# **Office of Utilities Regulation**

## **Update of the Cost Model for Fixed Interconnection Rates - The Decision on Rates**

### **Determination Notice**

**1. DOCUMENT NUMBER:** 2022/TEL/002/DET.001

**Table 2: Transit traffic (Historic and forecast) [Source: Updated Fixed Cost Model]**

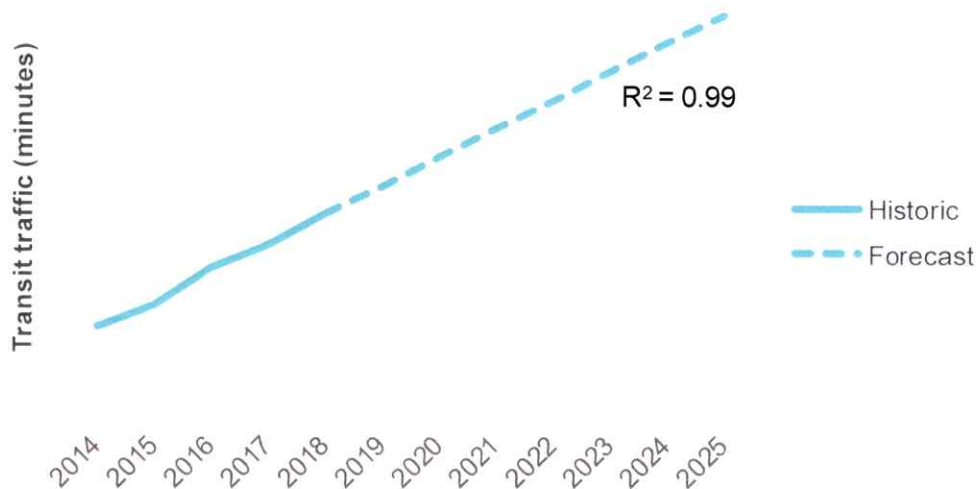
- 4.12. In its response to the Consultation Document, Digicel questioned the reason for the predicted doubling of the “transit” category over the modelled period in a scenario where all other traffic types are expected to decrease significantly, noting that “[t]he transit category is projected to move from 30% of all demand to over 60% of all demand over the period”. In its comment on Digicel’s response, Flow agreed with Digicel’s comment that the OUR should clarify why transit traffic should increase in light of the decreasing values for other types of voice traffic.

- 4.18. Regarding the apparent doubling of transit traffic, the OUR would like to clarify that the forecast of transit services has been generated using a regression with parameters taken from the historical period 2014 to 2018. In this period, an increasing trend was observed, and the OUR considers it unlikely that such a trend would reverse over the modelled time period. The regression used for the estimation of this traffic is depicted in Table 2 below.
